MEMORANDUM

TO: Cape Elizabeth Planning Board
FROM: Maureen O'Meara, Town Planner
DATE: June 16, 2020
SUBJECT: 287 Ocean House Rd Village Retail Site Plan

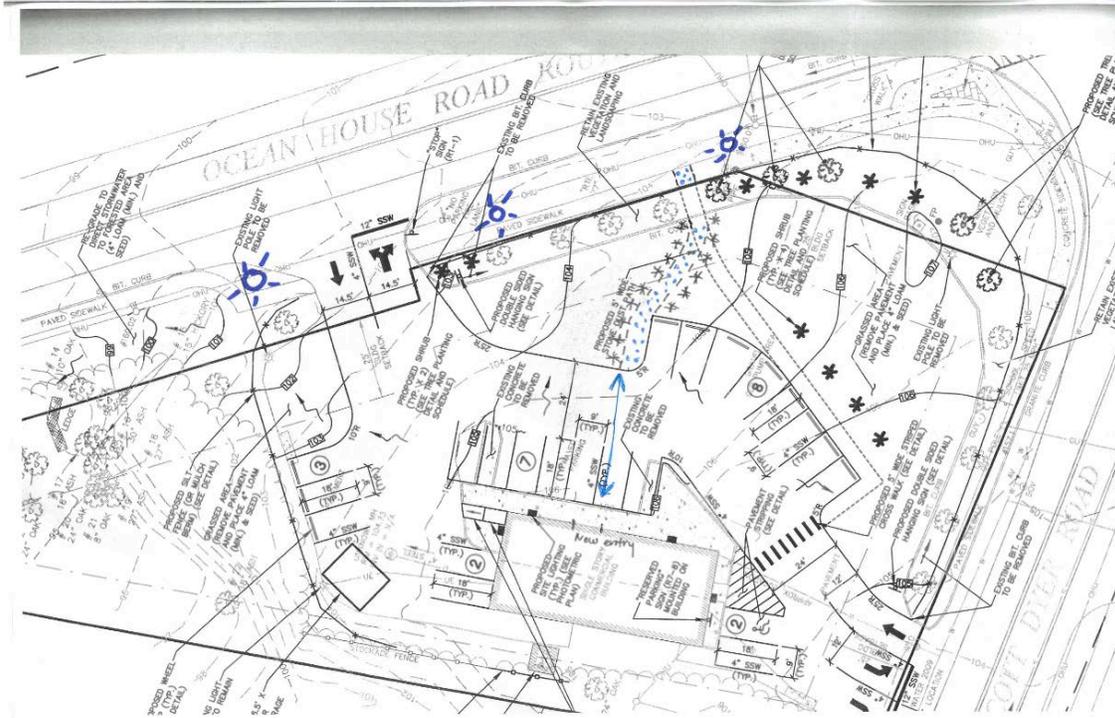
Front setback. The applicant has added a stone dust path that extends from Route 77, across the lawn, along the parking area to the south end. The proposed path is approximately 130' long. The Town Engineer, as well as other town staff, have observed that stone dust is problematic to maintain. The applicant may want to create a paver path similar to the one installed just north of the site.

The applicant may also want to reconsider the location and length of the proposed path. The sketch below shows an alternative path location connecting to the parking lot across from the front door of the building. This path is approximately 70' long. The reduced length may subsidize the increased cost of using pavers instead of stone dust. In order to enhance the path, the sides can be backfilled and planted with shallow rooted shrubs or perennials. The alternative design also reduces the opportunity to expand the proposed parking area into the proposed lawn area.
